A TENANT IMPROVEMENT AT 360 EUBANK BLVD. NE
LAUNDROMAT FOR TONY BYRNE

SITE PLAN

A-1

EXISTING SITE PLAN

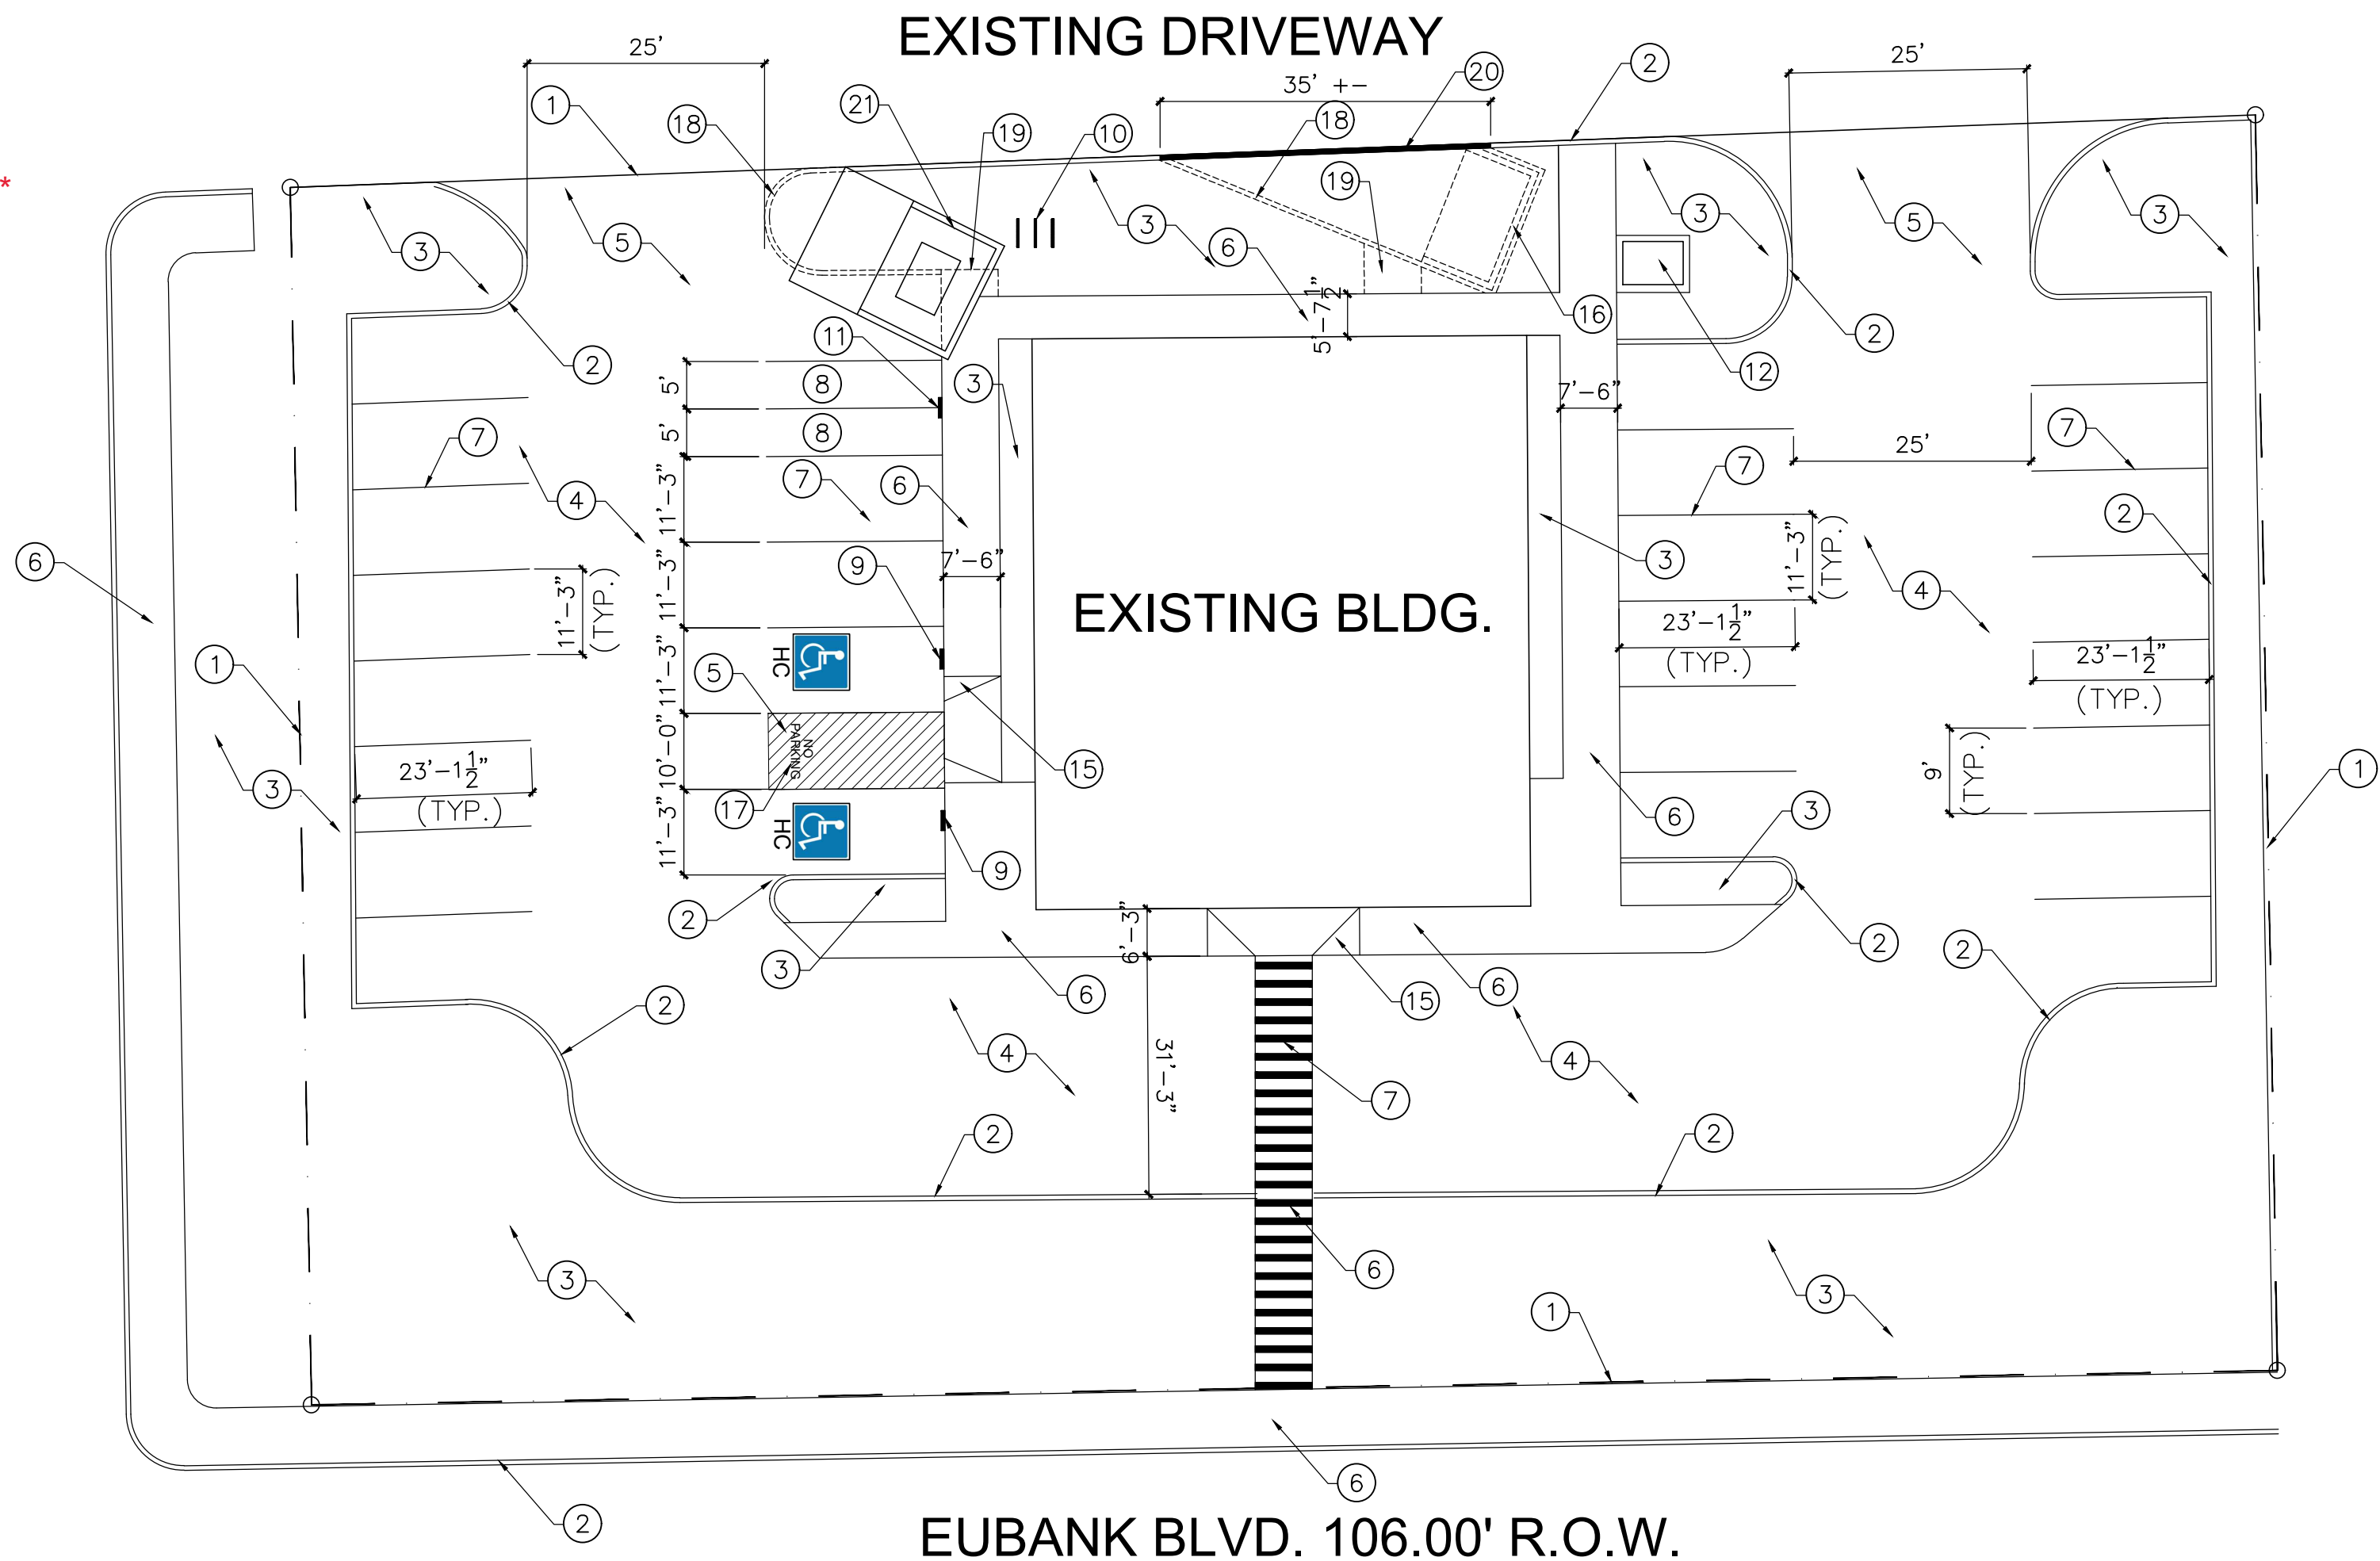
Approved for access by the Solid Waste Department
Herman Gallegos 06-16-21 *Herman Gallegos*
**Condition is all the existing curb in front and around
the trash enclosure has to be removed or approval is void.**
